PRE-CONSTRUCTION REQUEST FOR INFORMATION RESPONSES

Project: Covenant United Presbyterian Church

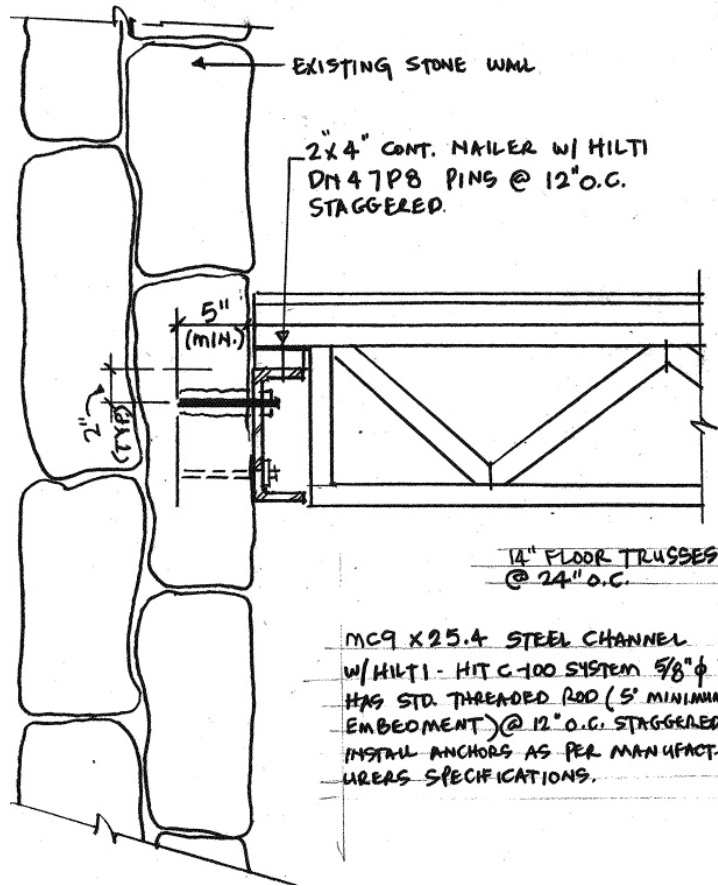
The same detail does not appear to show a connection of the existing floor trusses to the wall. Please advise.

Please see below for requested detail.
